## Product Change Notification

1. **ECR #:** 218869  
**Notification #:** 658

3. **Series:**  
• UMPS - UMPS ASSEMBLY

4. **Part #'s Affected**  
• UMPS-XX-XX.X-XX-V-X-X-XR

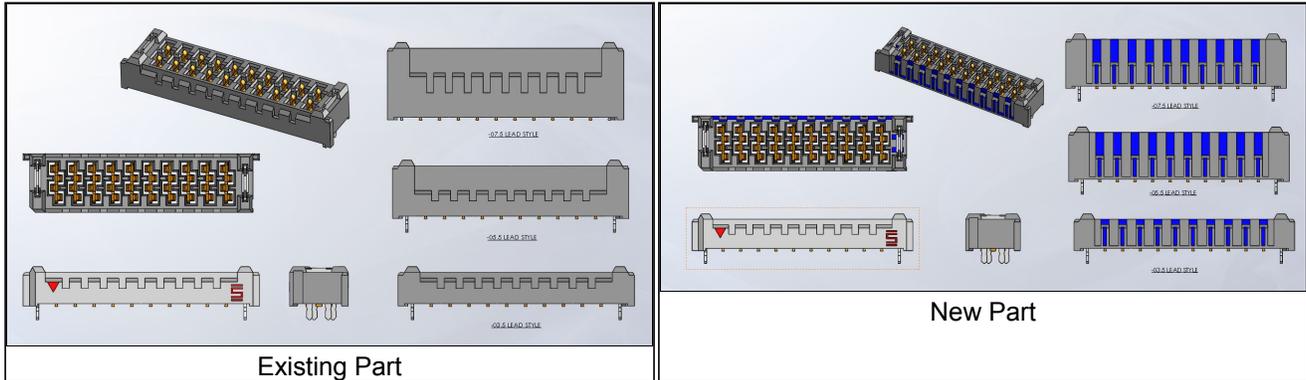
5. **Description of Change:**  
Change the outer void of side rib design and add void to right Weld tab hole.

6. **Method of Identifying Change**  
Visual inspection, see picture for the body changes highlighted in blue color.

7. **Reason for Change:**  
Change made to improve body knit line.

8. **Impact of Change on Form, Fit, or Function:**  
• Form - this is a rolling change and there is some opportunity for mixed inventory on a limited basis.
